MILITARY SPECIFICATION

CIRCUIT CARD ASSEMBLY 11747210
TARGET COINCIDENCE BOARD

This Amendment forms a part of Military Specification MIL-C-48581(AR), dated 20 November 1975, and is approved for use by the US Army Armament Munitions and Chemical Command and is available for use by all Departments and Agencies of the Department of Defense.

FIGURE 1. Circuit connections

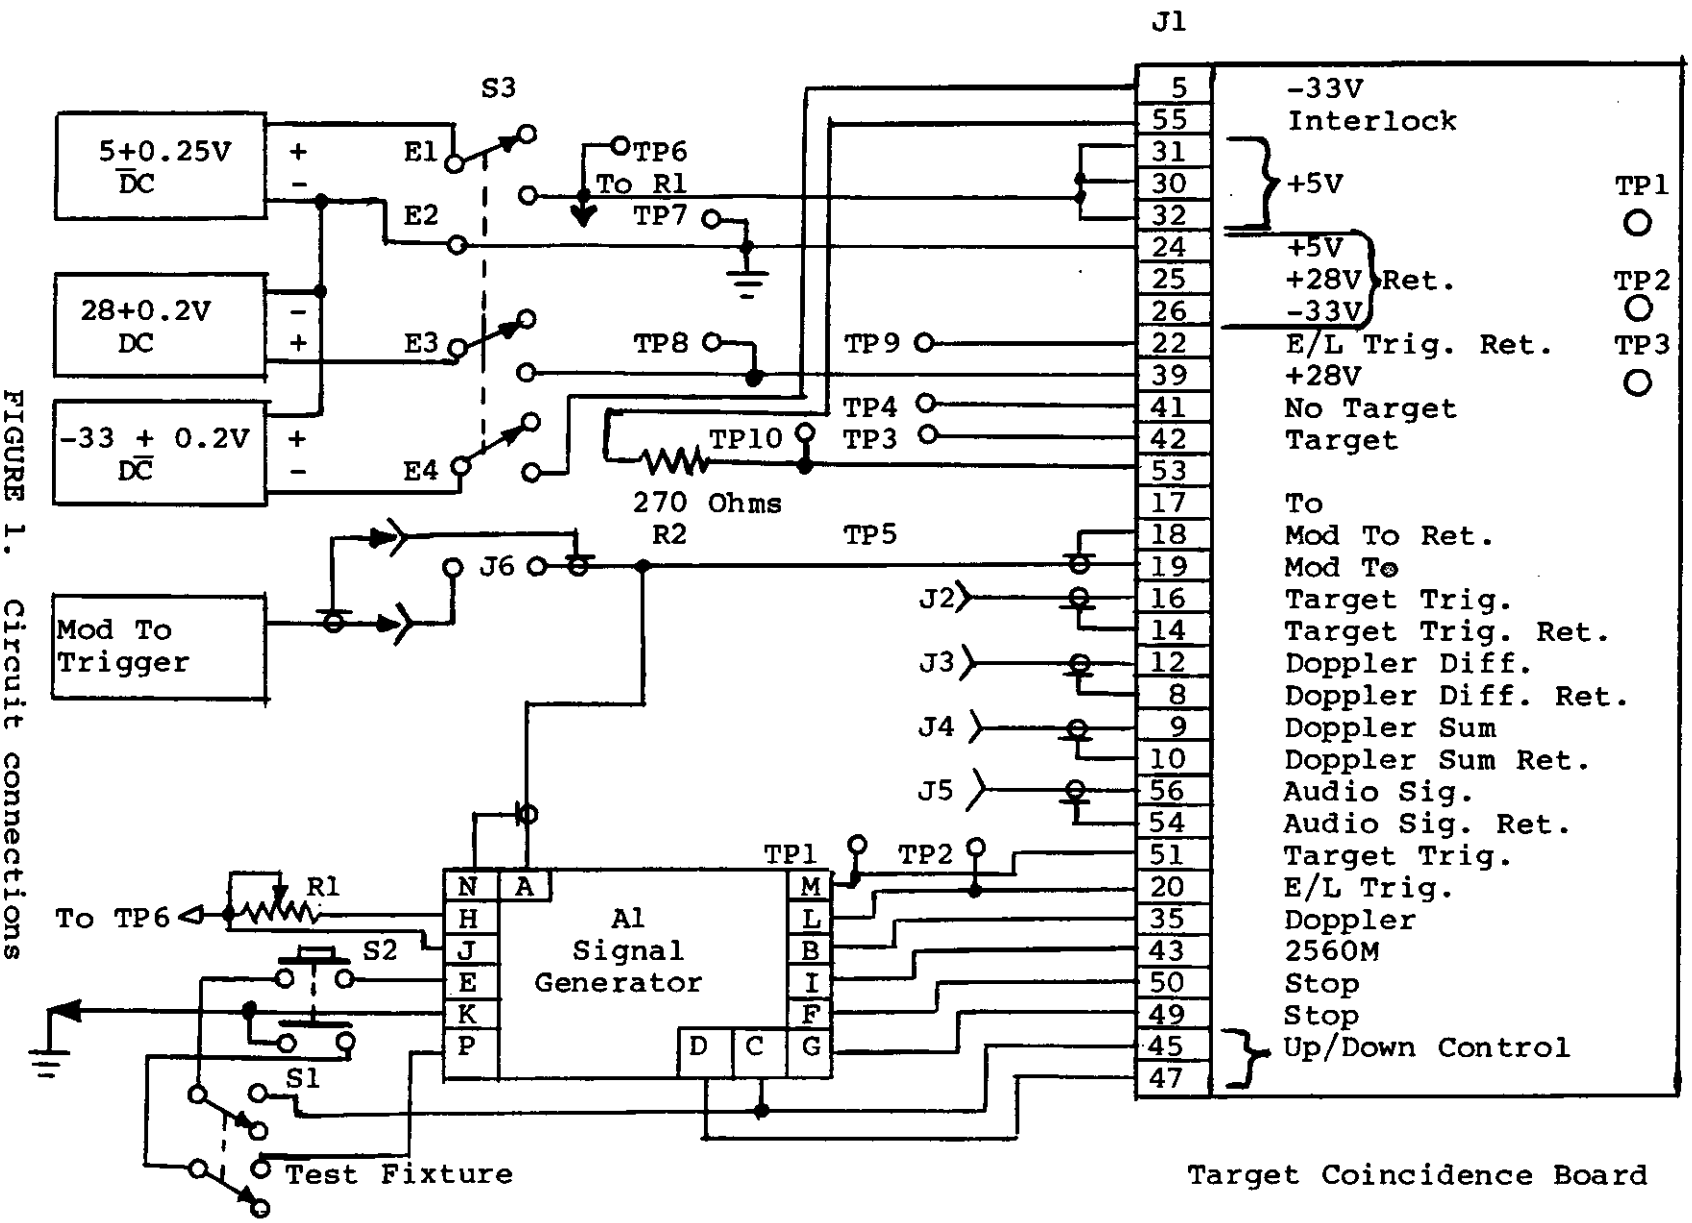
Figure 1: Delete and substitute new "Figure 1".

FIGURE 2. Test fixture

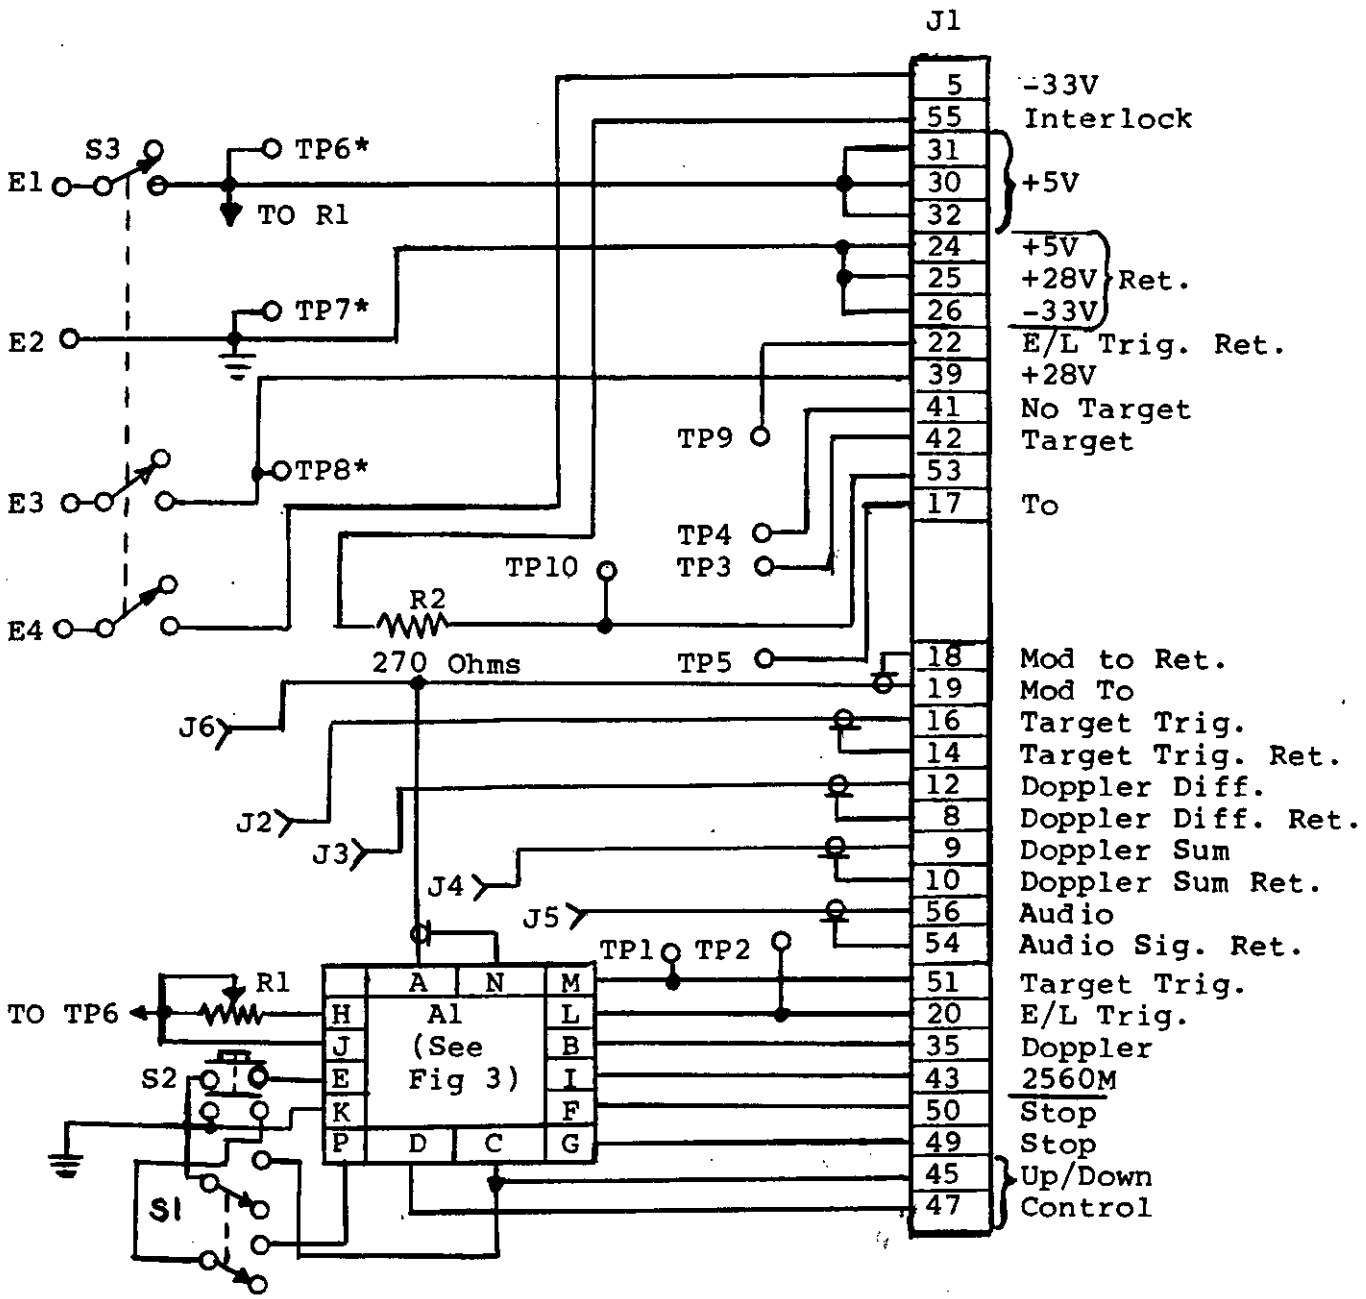
Figure 2: Delete and substitute new "Figure 2".

FIGURE 3. Test fixture signal generator A1

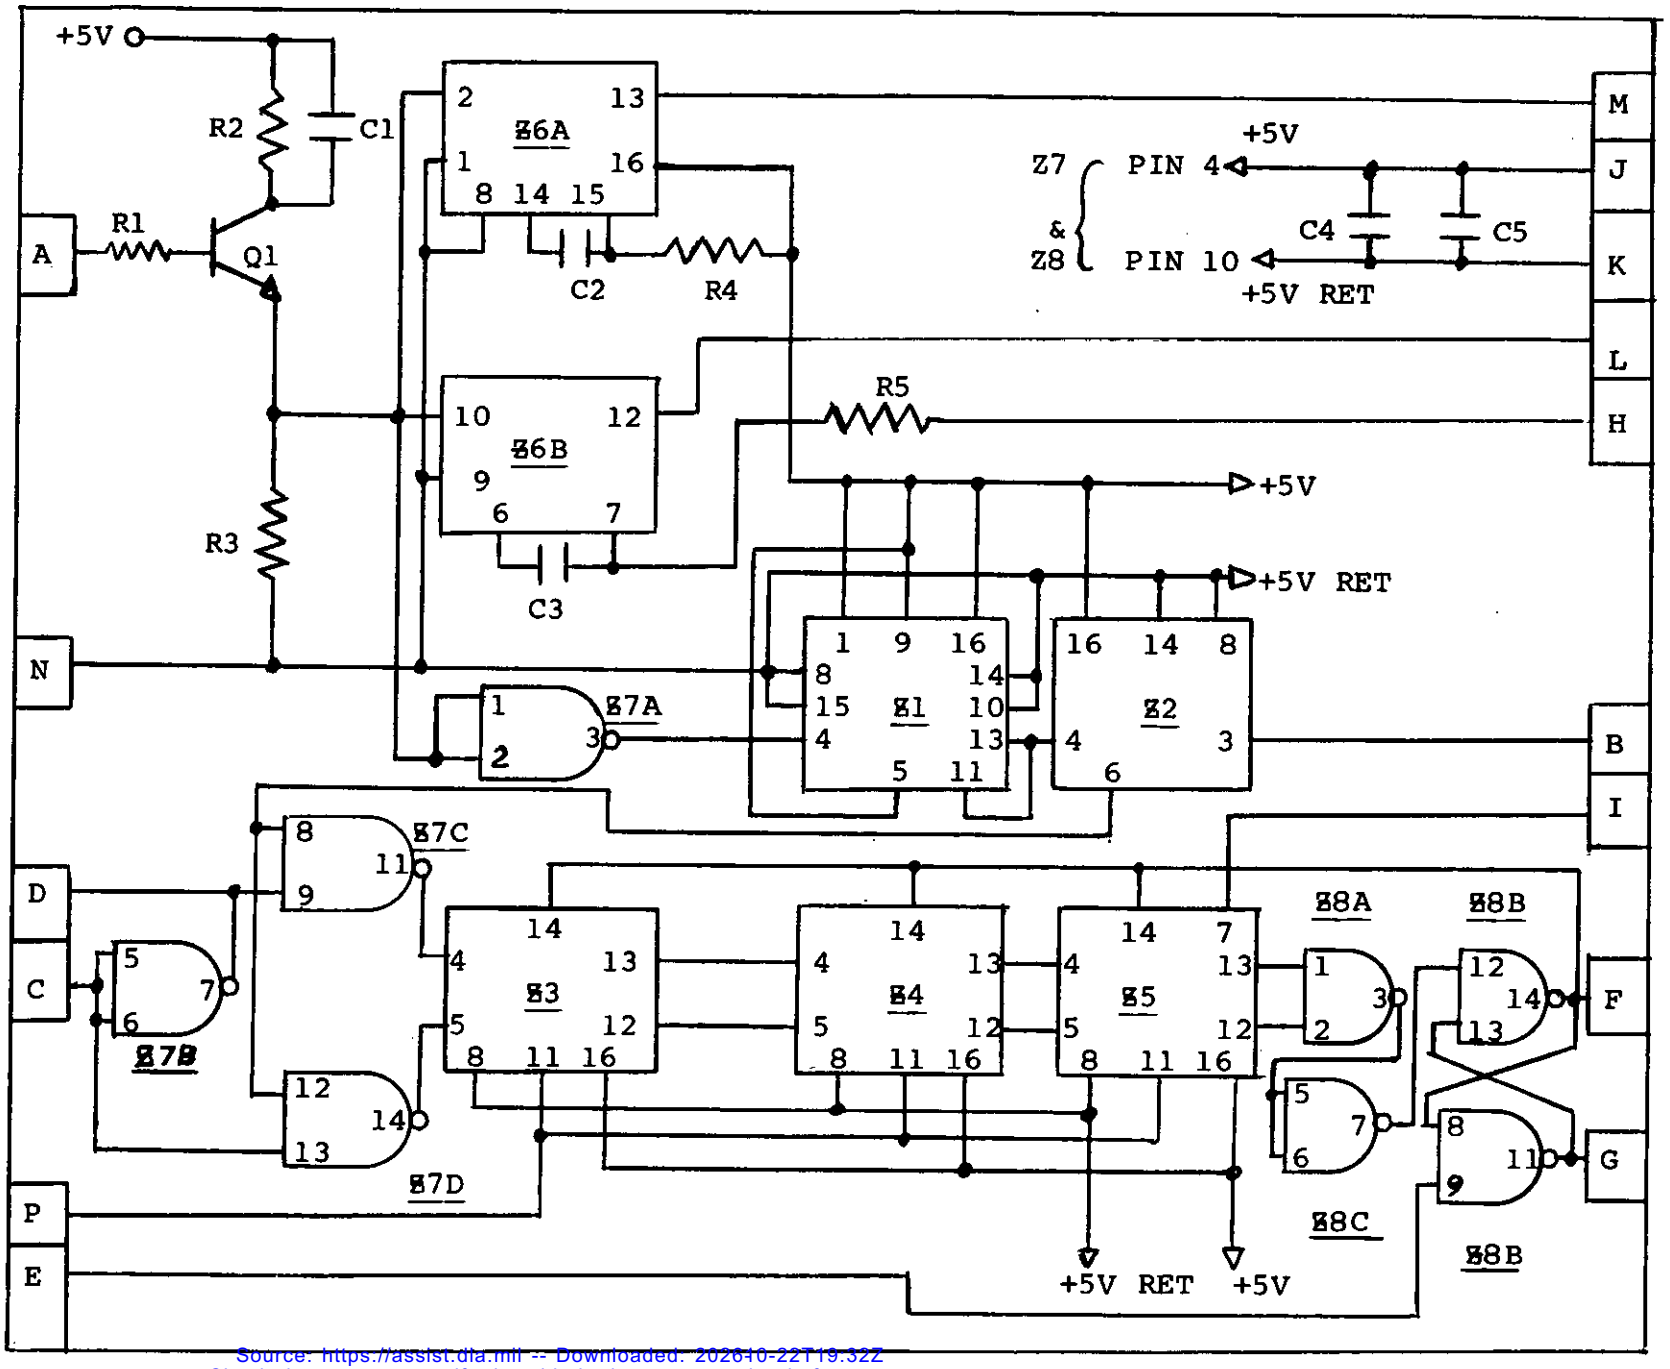
Figure 3: Delete and substitute new "Figure 3".
